**The W Nursing School
Neshoba General
Philadelphia, MS**

Addendum No. 2

June 10, 2026

This addendum forms a part of the contract documents and modifies the original plans and specifications dated June 4, 2026.

sheet no.
A-107

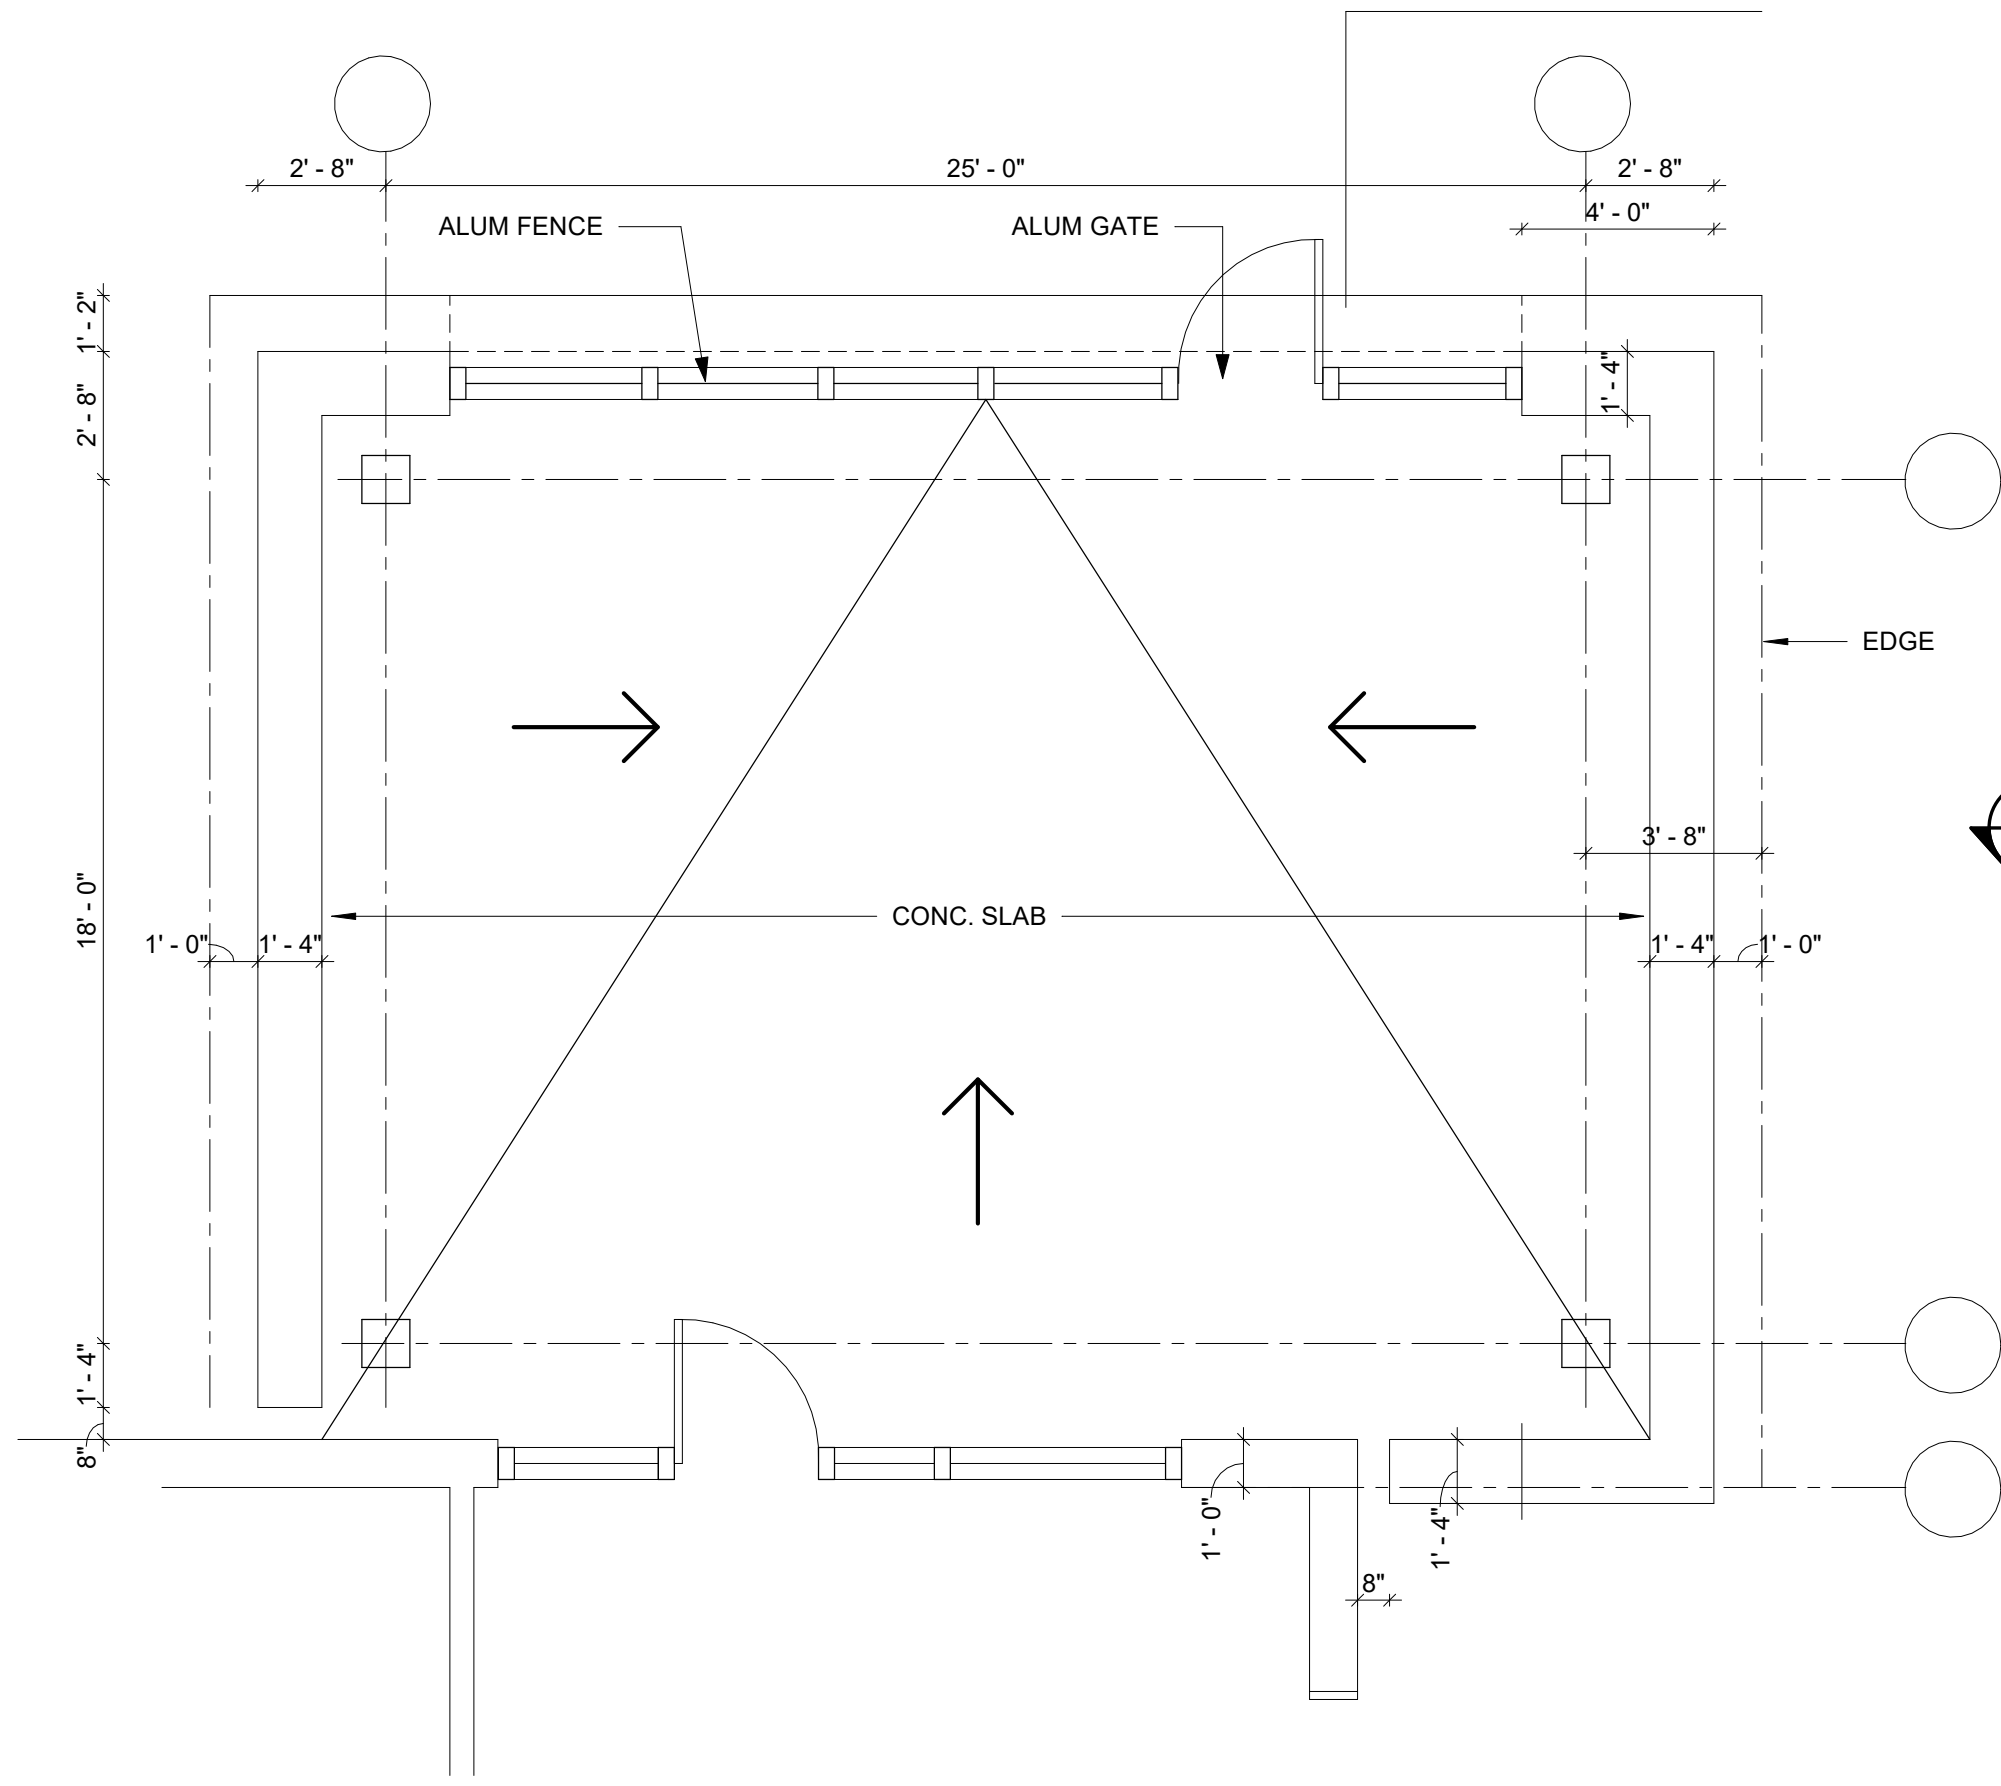
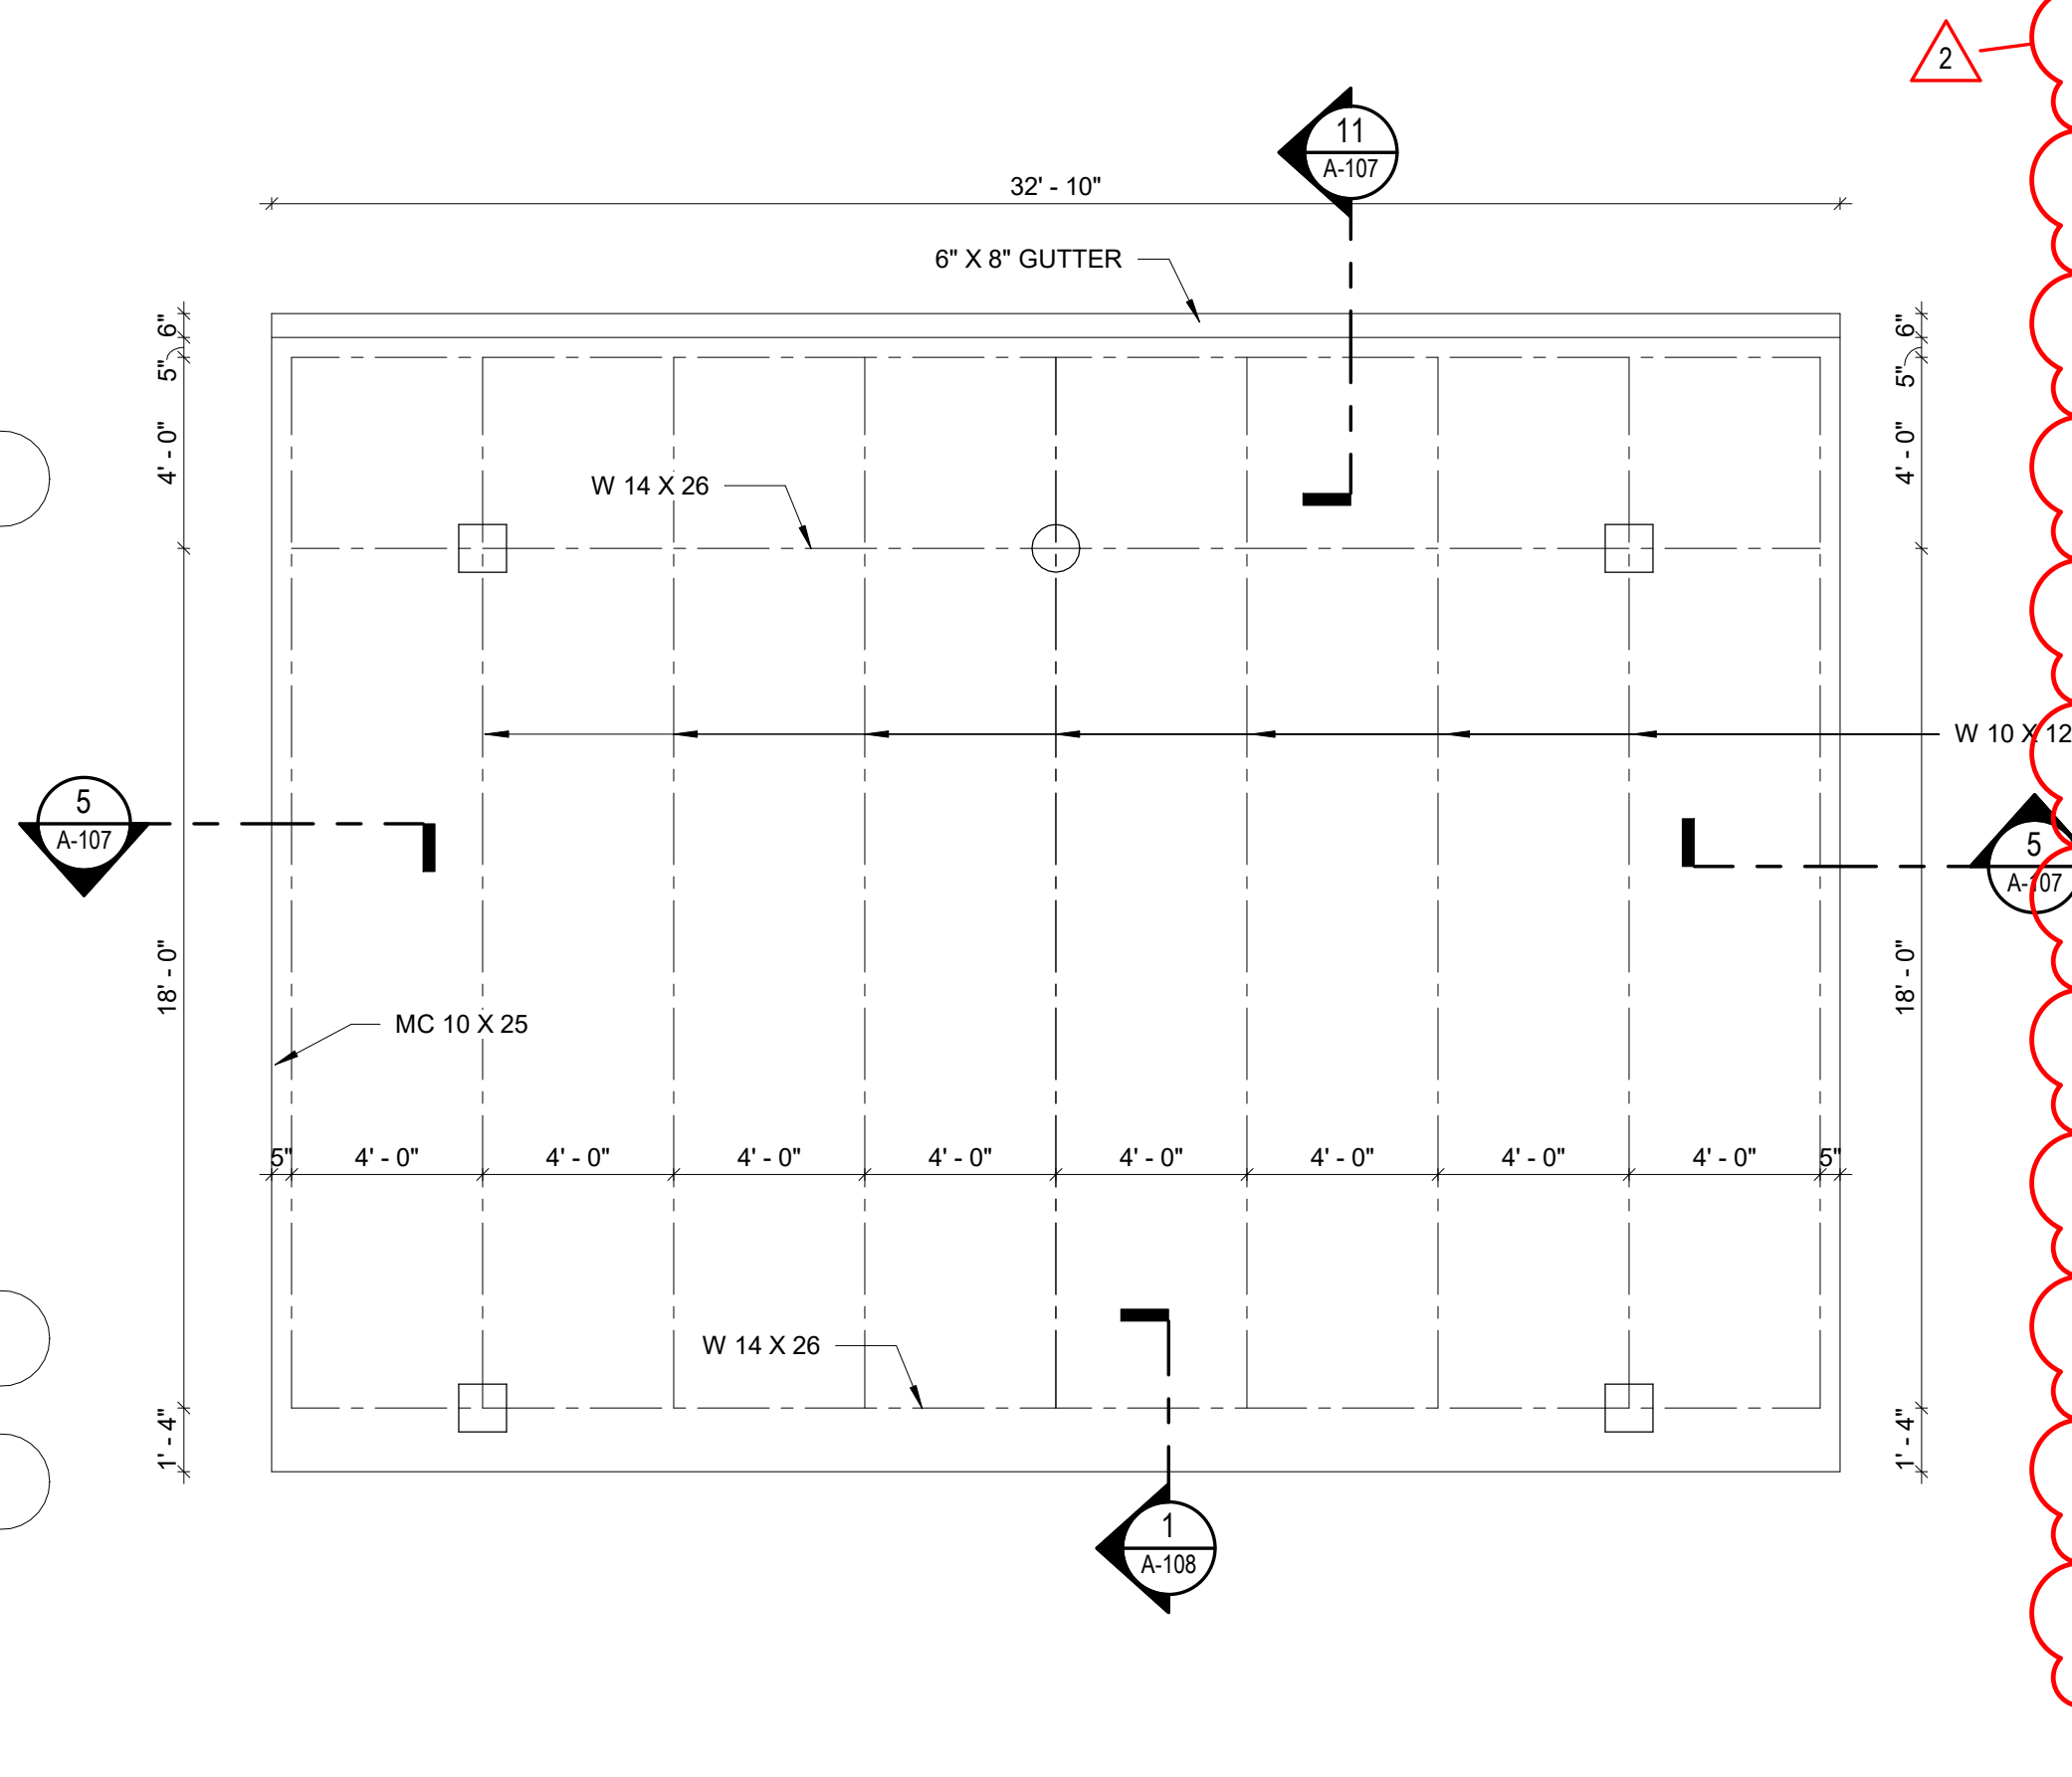
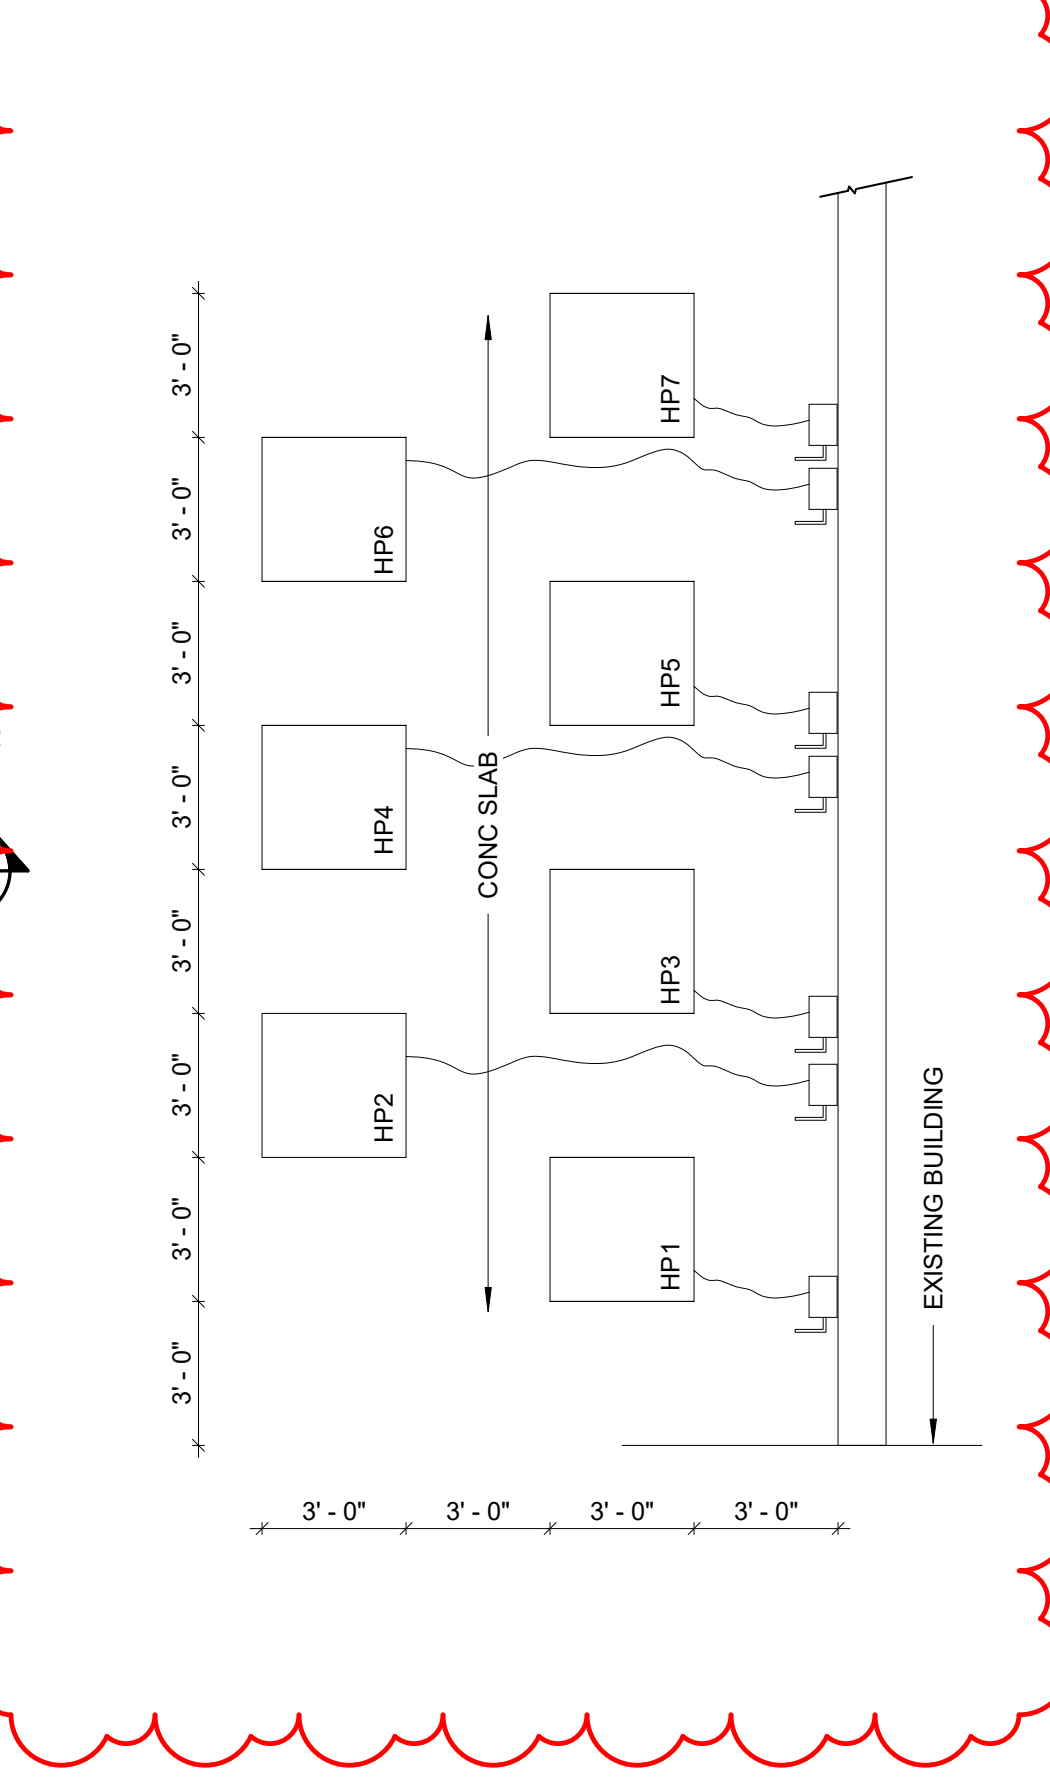
Item 2.6: Sheet A-107

Note: See clouded configuration 11/A107 of the condense units at the north end of the project.
